Arundel Street – Manchester

DESIGN & ACCESS STATEMENT ADDENDUM | APRIL 2022

This Design and Access Statement Addendum by SimpsonHaugh has been prepared in support of proposed amendments to the approved planning application (ref. 123261/FO/2019) for the following:

Levels 9-10 - Proposed Amendments

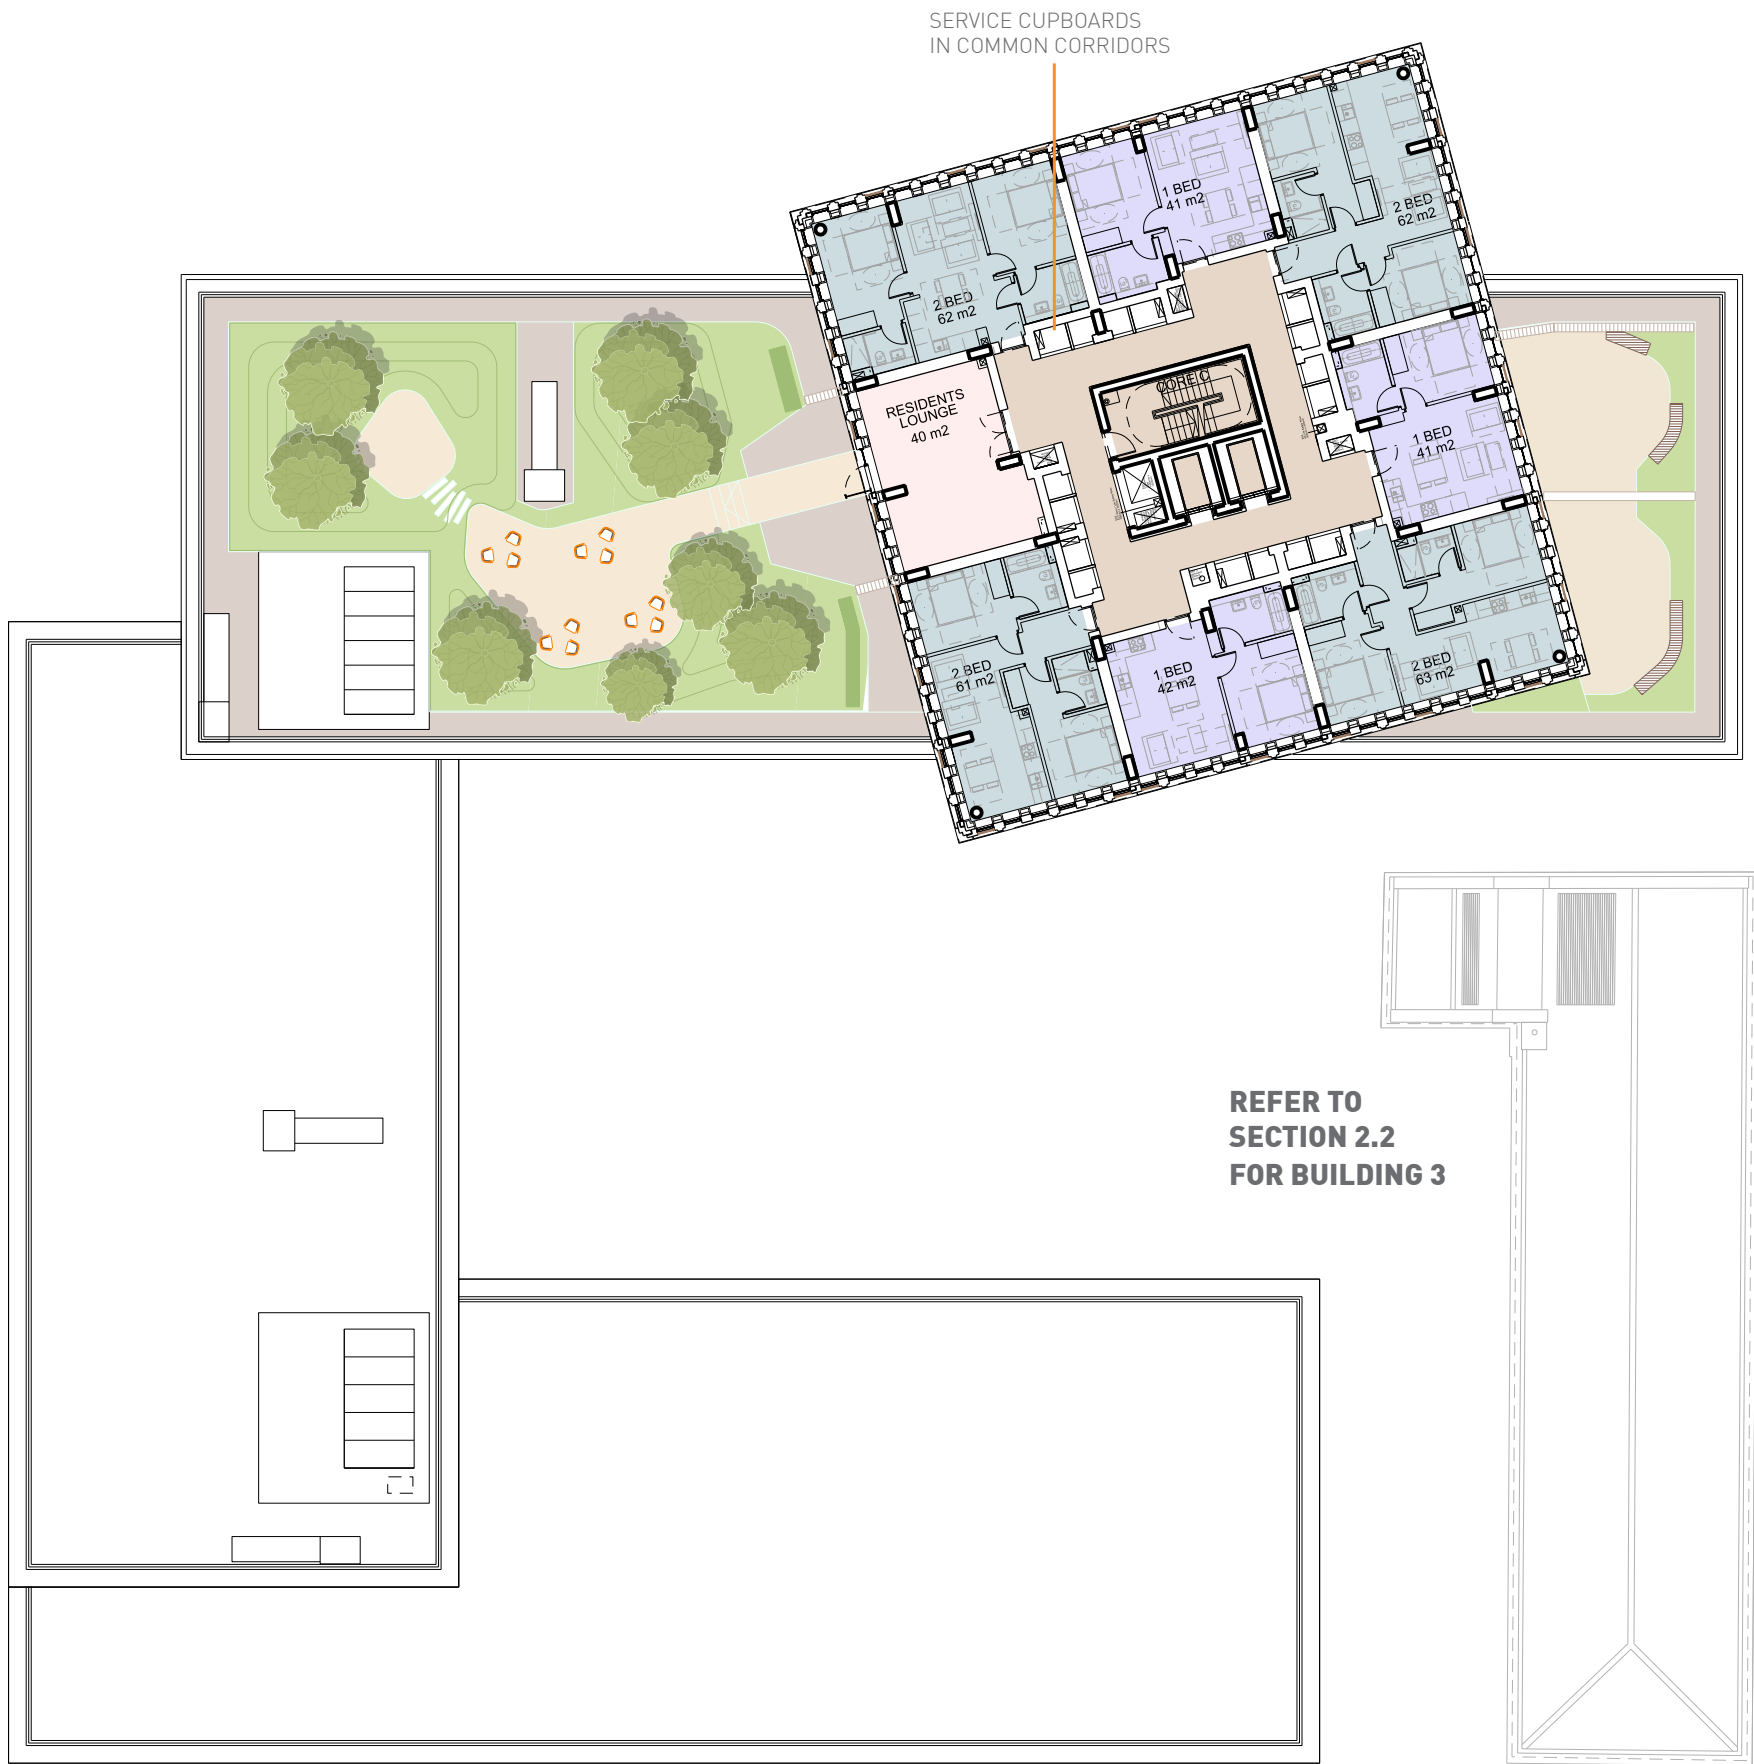
The arrangement of apartment and common circulation is similar to the lower levels.

At Level 9, the number of apartments remains as the approved scheme, with a combination of one, two and three bedroom units with either single or dual aspect.

Access to the communal roof garden is improved through the provision of the link corridor between the cores. An new internal communal amenity space is proposed adjacent to Core B as an enhancement to the approved scheme.

The roof level of the projecting lift overrun enclosure to Core A has increased in height by 665mm to suit the revised passenger lift configuration. Roof mounted plant has been amended to suit the amended configuration of the common areas below.

At Level 10, the number of apartments has been amended from 14No to 15No units.

- 01 APARTMENT LAYOUTS AMENDED TO ACCOMMODATE UNITS DECANTED FROM BUILDING 3 AND FOR THE PROVISION OF NEW RESIDENTIAL AMENITY SPACES ON LEVELS 08, 09, 11 & 22
- 02 SERVICE CUPBOARDS INTEGRATED INTO ALL APARTMENT - APPLIES TO ALL FLOORS
- 03 THROUGH APARTMENTS OMITTED
- 04 LINK CORRIDOR BETWEEN CORES B & C
- 05 CORE ARRANGEMENT AMENDED TO SUIT NEW RESIDENTIAL AMENITY SPACES AND CURRENT BUILDING REGULATIONS
- 06 NEW RESIDENTIAL AMENITY SPACE ADDED
- 07 AMENDMENT OF ROOF MOUNTED PLANT TO SUIT ADJUSTMENTS TO COMMON AREAS BELOW
- 08 INCREASE IN CORE HEIGHT BY 665MM TO ACCOMMODATE REVISED LIFT OVERRUN

Level 11 - Proposed Amendments

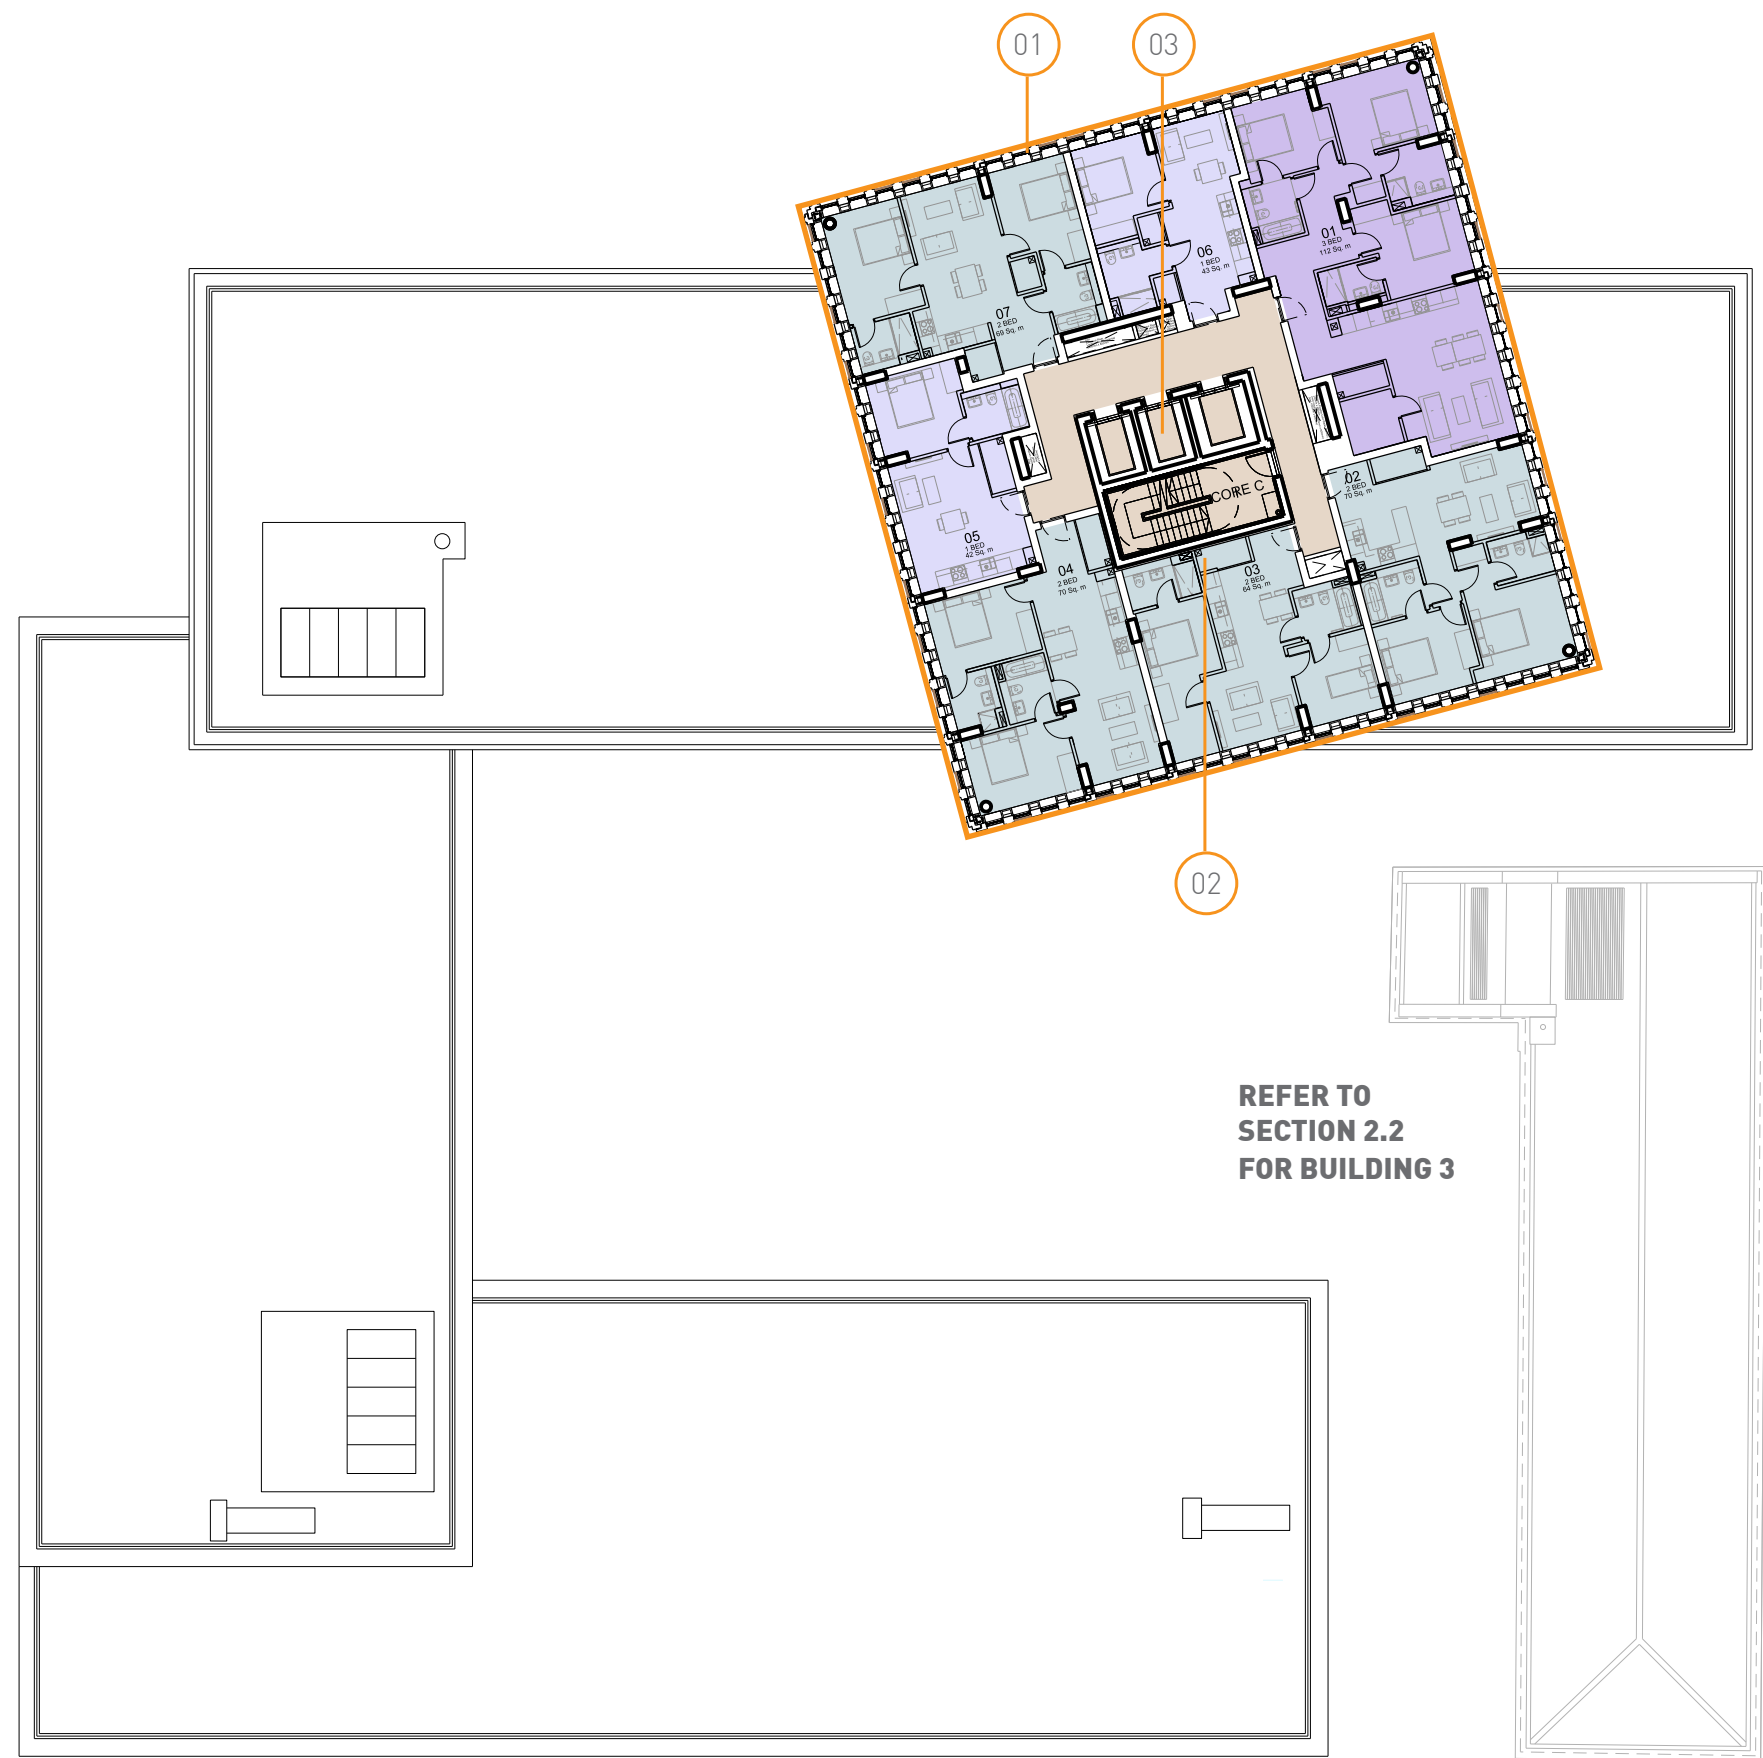
The mix of apartments has been amended to include one, two and three bed units at this level and the number of units on the floor has amended from 7No to 5No.

The internal communal amenity space has been retained and enlarged to incorporate the northeast corner of the building and will benefit from a dual aspect orientation.

The roof level of the projecting lift overrun enclosure to Core B has increased in height by 665mm to suit the revised passenger lift configuration. The life safety generator flue which previously terminated at the roof level of Core C has been relocated to Core B and terminates 300mm above the roof level.

The provision of communal and private roof gardens remains as the approved scheme. Roof mounted plant has been omitted to suit the amended configuration of the common areas below.

- 01 APARTMENT LAYOUTS AMENDED TO ACCOMMODATE UNITS DECANTED FROM BUILDING 3 AND FOR THE PROVISION OF NEW RESIDENTIAL AMENITY SPACES ON LEVELS 08, 09, 11 & 22
- 02 SERVICE CUPBOARDS INTEGRATED INTO ALL APARTMENT
- 03 CORE ARRANGEMENT AMENDED TO SUIT NEW RESIDENTIAL AMENITY SPACES AND CURRENT BUILDING REGULATIONS
- 04 RESIDENTIAL AMENITY SPACE ENLARGED
- 05 AMENDMENT OF ROOF MOUNTED PLANT TO SUIT ADJUSTMENTS TO COMMON AREAS BELOW
- 06 INCREASE IN CORE HEIGHT BY 665MM TO ACCOMMODATE REVISED LIFT OVERRUN
- 07 LIFE SAFETY GENERATOR FLUE TERMINATES AT ROOF LEVEL OF CORE B

Levels 20-21 - Proposed Amendments (extract)

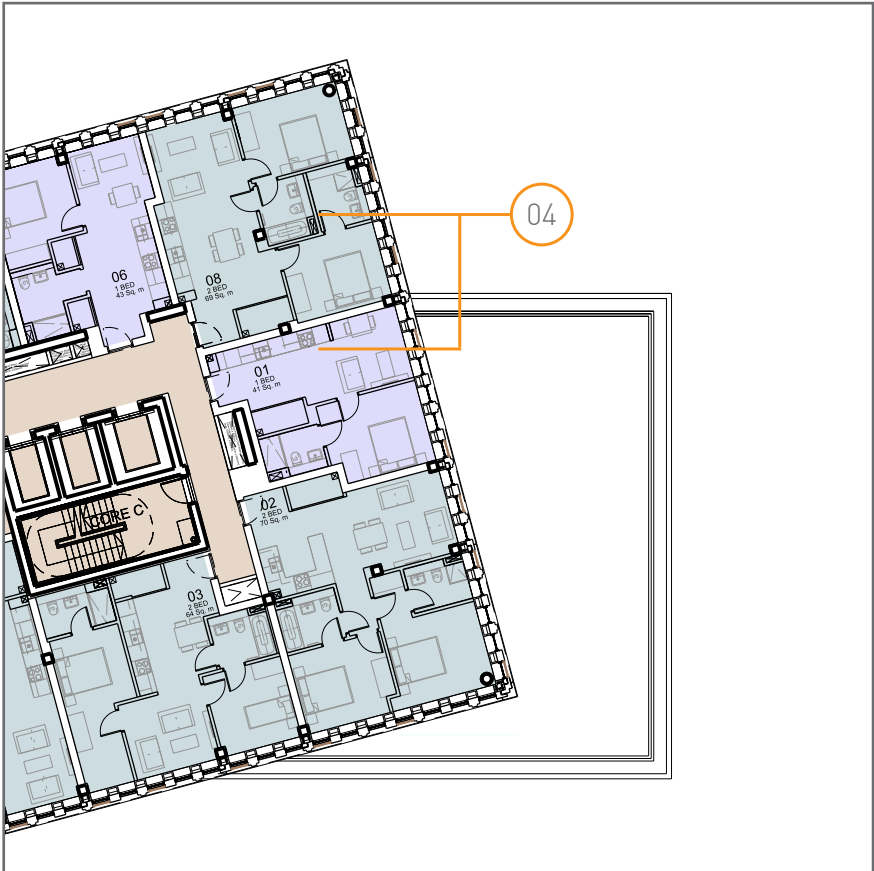
The layout of the apartments has been revised and is similar to Level 11, with the exception of the resident's amenity space, which is replaced by two apartments.

On Levels 12-19, the number of apartments on each floor remains as the approved scheme.

On Levels 20-21, the three bed apartment on the southeast corner is replaced with 1No one bed and 1No two bed apartment.

- 01 APARTMENT LAYOUTS AMENDED TO ACCOMMODATE UNITS DECANTED FROM BUILDING 3 AND FOR THE PROVISION OF NEW RESIDENTIAL AMENITY SPACES ON LEVELS 08, 09, 11 & 22
- 02 SERVICE CUPBOARDS INTEGRATED INTO ALL APARTMENT
- 03 CORE ARRANGEMENT AMENDED TO SUIT NEW RESIDENTIAL AMENITY SPACES AND CURRENT BUILDING REGULATIONS
- 04 1 BED AND 2 BED UNITS AT LEVELS 20 AND 21

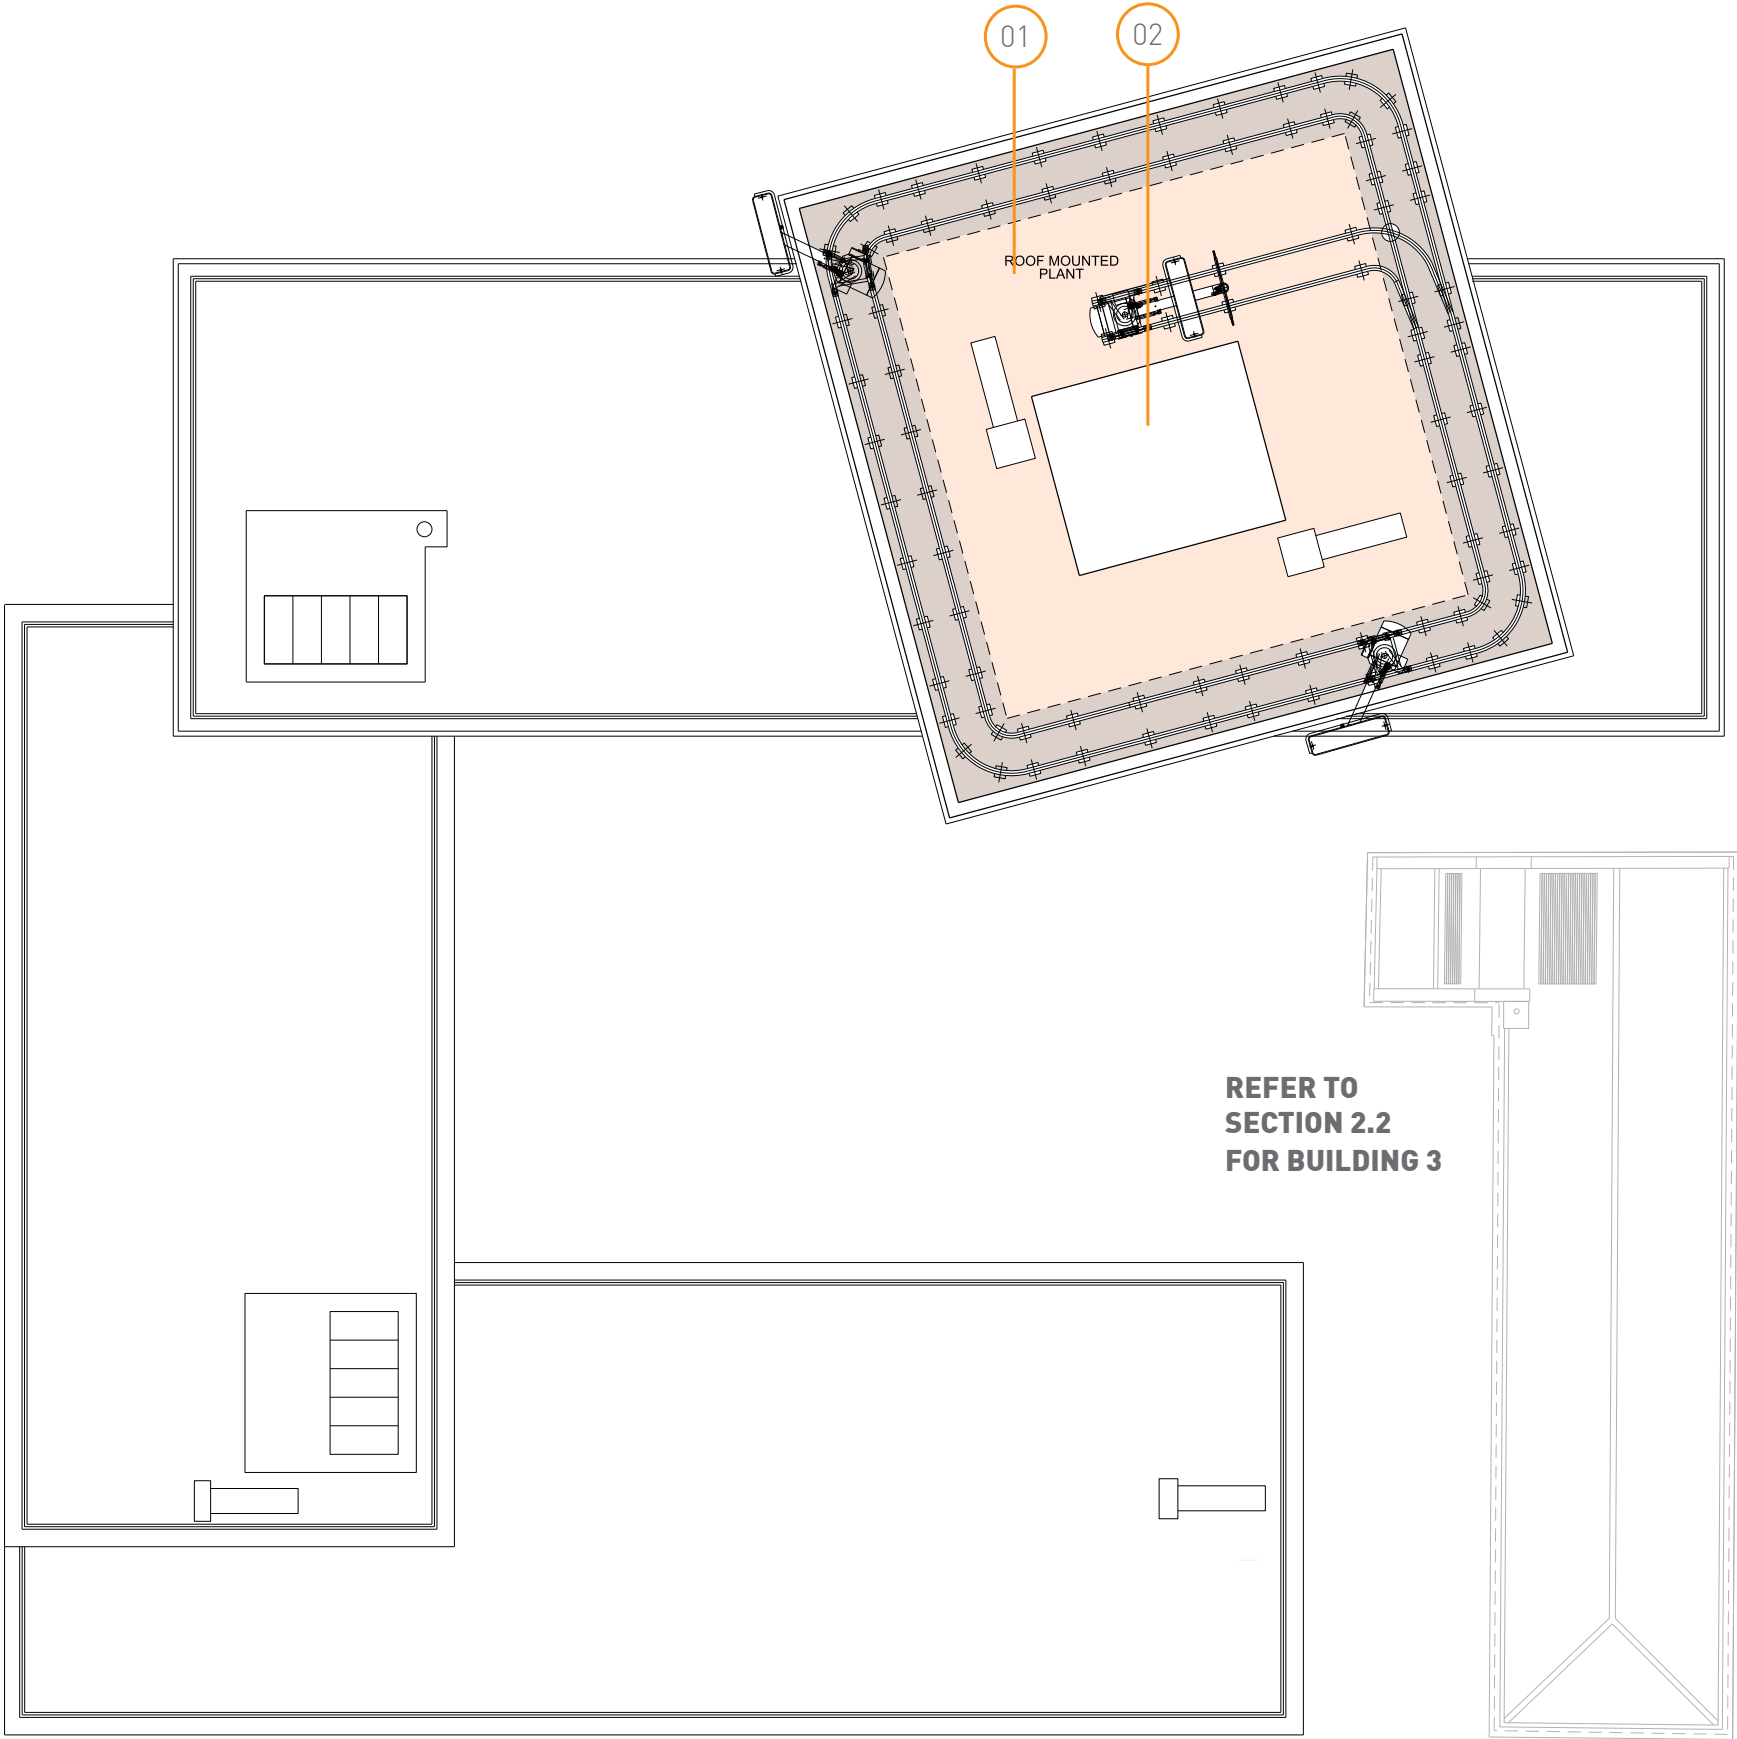
The layout remains as the approved scheme with the exception of an amendment to the core footprint to suit the reconfigured arrangement below.

- 01 AMENDMENT OF ROOF MOUNTED PLANT/CORE FOOTPRINT TO SUIT COMMON AREAS BELOW
- 02 INCREASE IN CORE HEIGHT BY 400MM TO ACCOMMODATE REVISED LIFT OVERRUN
